**risks of reactor**  
**Lifetime extension**  
**Doel-4 and Tihange-3**

Opinion within the scope of the EIA procedure

Oda Becker, Gabriele Mraz (pulswerk GmbH )

Commissioned by Greenpeace Belgium and Bond Beter Leefmilieu

Figure 1: Major accident contamination at Doel-4 in Bq Cs-137 per m<sup>2</sup>. Source: flexrisk.boku.ac.at.

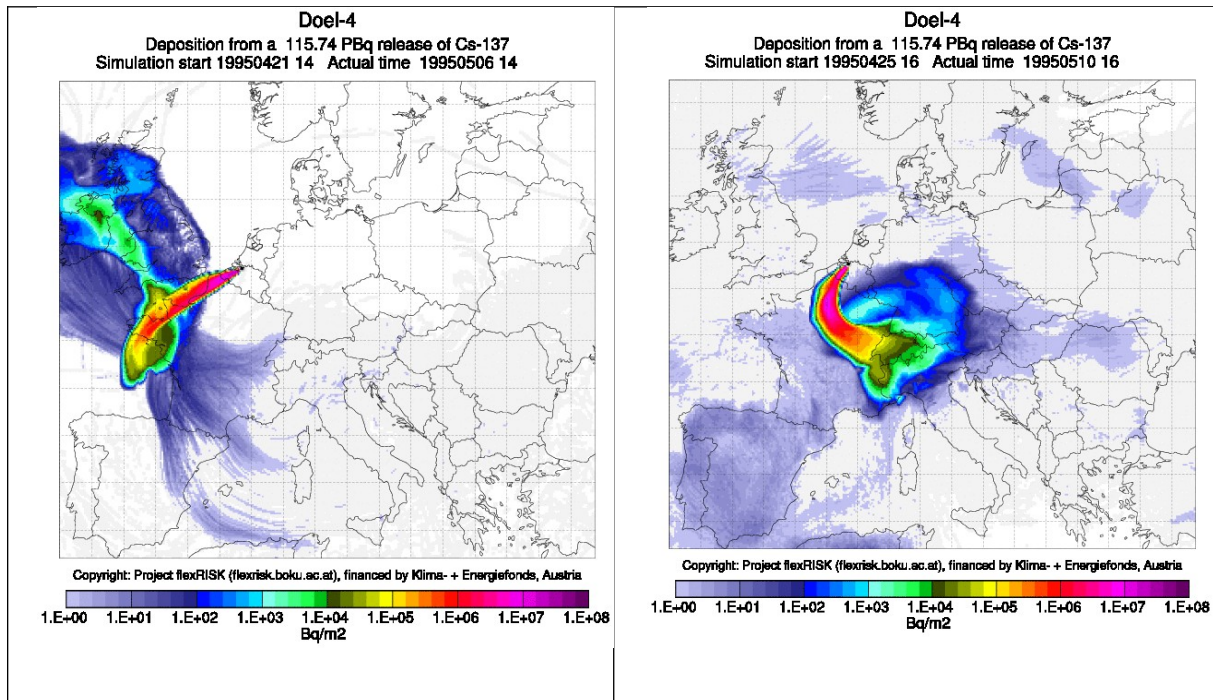
It is easy to see that the possible contamination from this assumed serious accident depends heavily on the weather. **Due to the weather conditions, large parts of Europe can be affected, as can be seen from the location and size of the orange, red and purple areas. For example, the radioactive cloud from a severe accident in Doel-4 would initially move to the south-east (via Luxembourg) under weather conditions like those of April 9, 1995, then move on via central and southern Germany, turn off via the Czech Republic, Austria and Switzerland and move on to Italy.**

However, it must be taken into account that these calculated accidents are by no means the worst possible accidents. **In the flexRISK project, a possible accident with containment failure was calculated for both reactors. These results show that large parts of Europe could become contaminated.** Areas northeast of the relevant nuclear power plants have the highest weather-related probability of being contaminated by a severe accident. **Such an accident could even result in areas in and around Belgium having to be resettled.**

**The transboundary impacts for a major accident should be calculated in the EIA process, regardless of the estimated probability of occurrence, as long as it is physically possible in order to clarify the risk. The results of the flexRisk project determined the massive impact of such an accident for Belgium and Europe.**

Figure 3: Weather-related probability of being contaminated by a severe accident in Doel-4 and Tihange-3 with more than 37 and 1,480 kBq Cs-137/m<sup>2</sup>. Source: flexrisk.boku.ac.at.

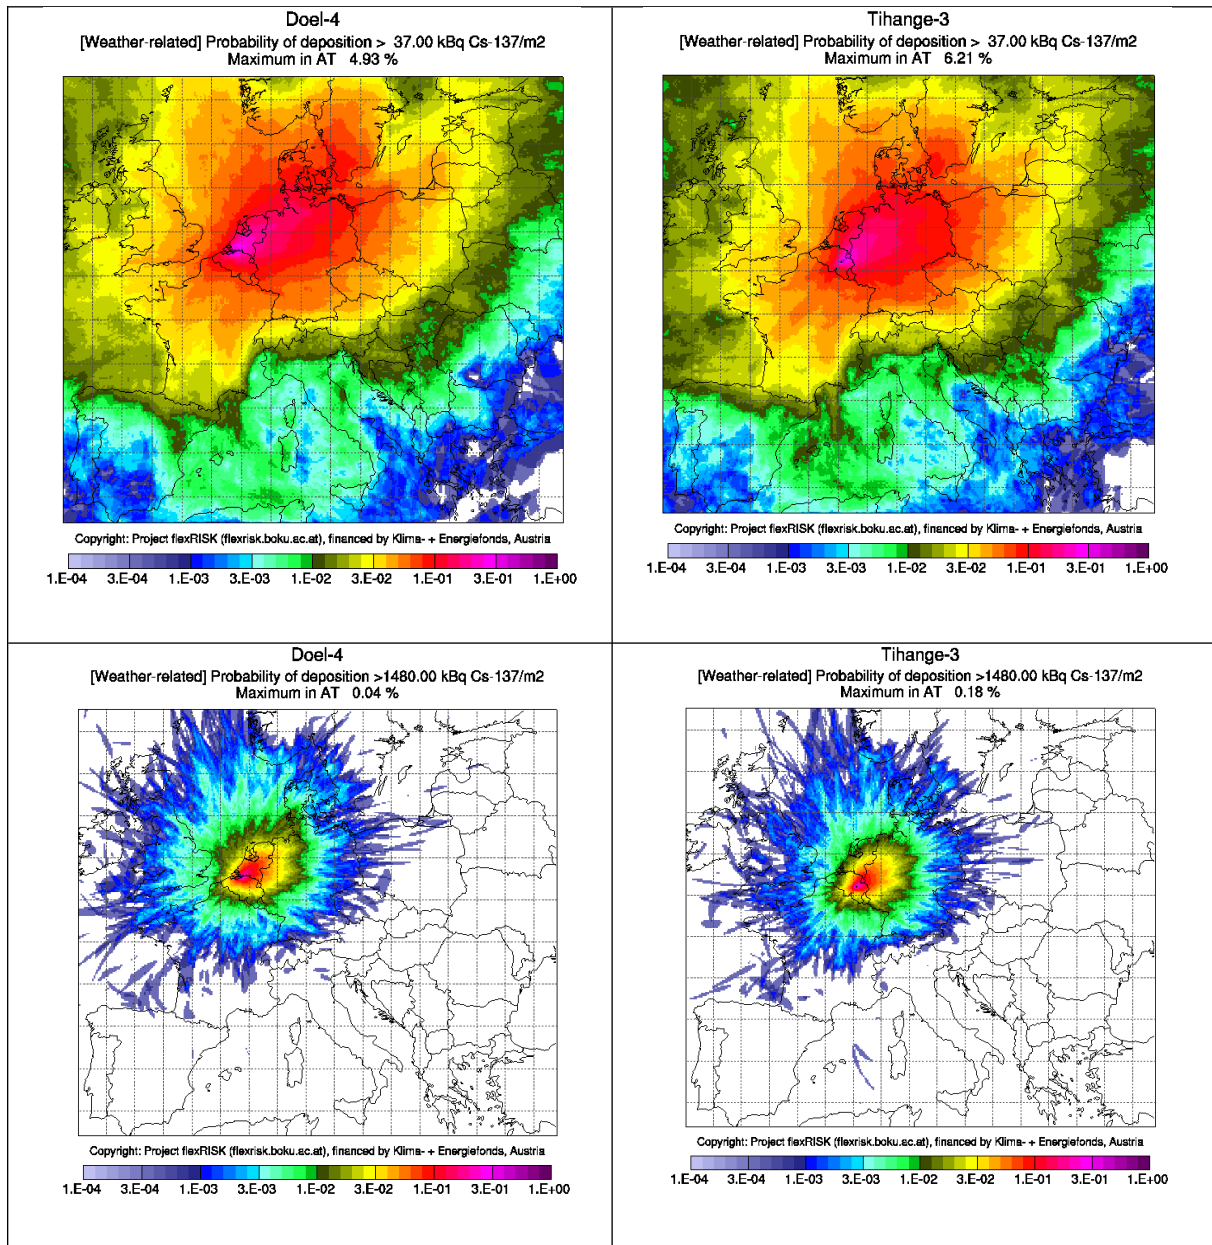
Areas northeast of the relevant nuclear power plants have the highest weather-related probability of being contaminated by a severe accident, this is the most common wind direction. **The two lower figures (probability of contamination with 1,480 kBq Cs-137/m<sup>2</sup>) show which areas have a high probability of having to be evacuated in the event of the assumed serious accident; these are by no means only areas in Belgium, but also in the neighboring countries, with a higher probability in the north-east direction.**
